Service Bulletin

Ref. No. : EG-6009

Subject : DTC P1345/1349 - VVT-I SYSTEM MALFUNCTION - VVT CONTROLLER INSTALLATION

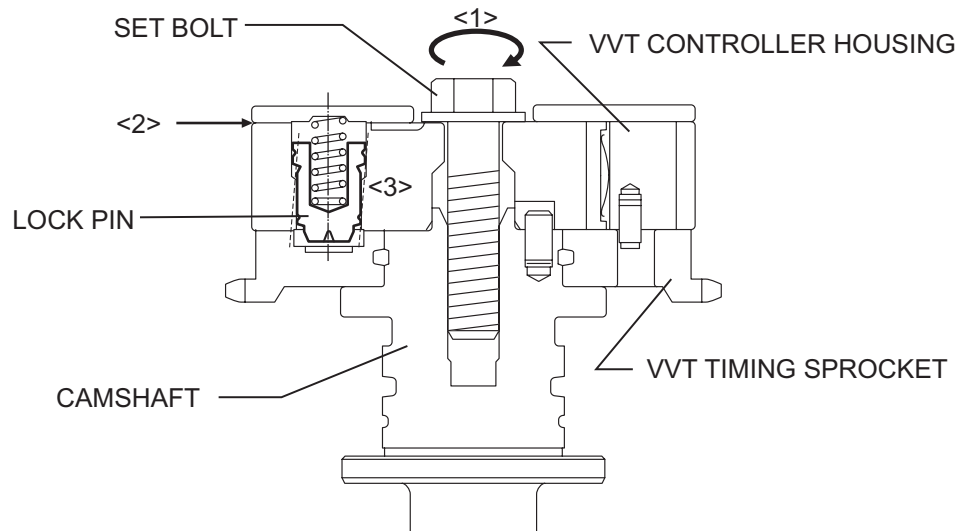
The "VVT controller" is installed on the camshaft by tightening the "set bolt". During the tightening of the set bolt, it is absolutely necessary that the "VVT timing sprocket" doesn't rotate relatively to the "VVT controller".

- If during the tightening of the "set bolt" [1.], the "VVT controller housing" rotates relatively (clockwise) to the "VVT timing sprocket", the VVT controller is locked in the retarded position by the "lock pin".
- If the set bolt is then more tightened, a high shear force is applied to the lock pin [2.].
- This causes a slight tilting of the lock pin in its bore and finally a complete jamming of the lock pin [3.].
- The lock pin cannot be disengaged anymore by the oil pressure.
 - (a)VVT controller cannot rotate intake camshaft
 - (b)Big difference between target and actual adjustment angle
